Caerphilly County Borough Local Development Plan

**HG1.25 (FC38) - Navigation Colliery, Crumlin
(Incorporating the Joint Statement Of Common
Ground Between Caerphilly County Borough
Council and Environment Agency Wales)**

ED21

EAW Model 0.1% Flood Outline

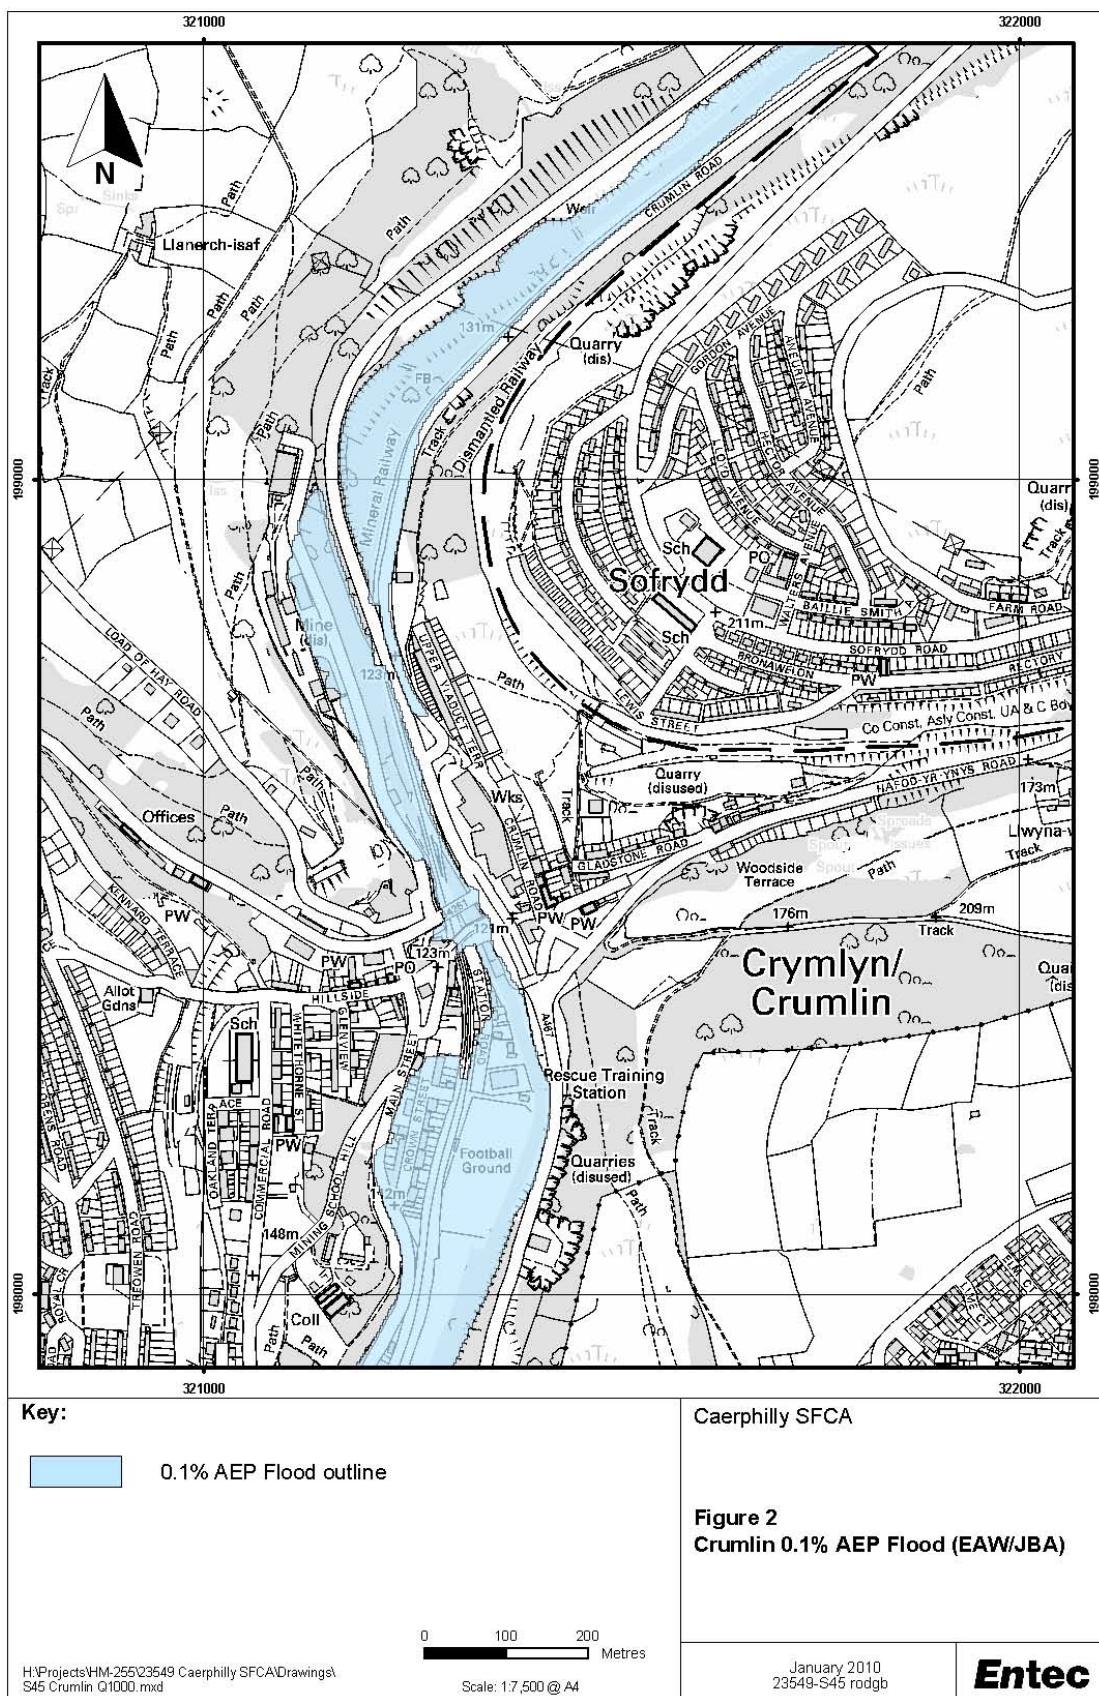
- S6 EAW presented output from their model that had been completed in August 2009. The flood outline for the 0.1% extreme flood from the EAW Model appeared similar to the outline shown by the CCBC Model (EAW and Entec Models flood outlines are included as Appendices 2 and 3 respectively). The site is long and narrow and is constrained by steeply rising land along the western part, which incorporates a rise of 12.5 metres at the western extent of the 0.1% extreme flood outline. Given this change in levels, Entec anticipated that flood levels would have to rise by approximately 15 metres before significant expansion of the flood extent occurred.

- S14 It was agreed that if the site allocation was constrained to prevent development in the 0.1% extreme flood outline, the downstream impacts and necessary mitigation could be properly assessed at a detailed planning stage. It was agreed that the most conservative 0.1% extreme flood outline is used to inform this to compensate for the differences between both models.

- S15 Following the meeting, Entec did some work to compare both models. Even though they considered that it was possible that the 1% flood event plus 50% blockage scenario to be more severe than the 0.1% extreme flood event outputs from the CCBC Model, they considered that the flood levels used in the EAW Model to be sufficiently conservative to compensate for this difference. It was concluded that the EAW modelled 0.1% extreme flood outline should be therefore be used.

- 1) It was agreed that the 0.1% extreme flood outline from the EAW Model is used to inform at a strategic level the amount of developable area on site. This outline is included as Appendix 2.
- 2) It was agreed that the detailed assessment of impact on flood risk elsewhere, particularly downstream, would be more appropriately addressed by the proposed developer at the detailed planning stage.
- 3) It was agreed that the site was significantly constrained by flooding and this would restrict the area of development, except where a developer was able to provide appropriate evidence by way of an assessment that would confirm that development
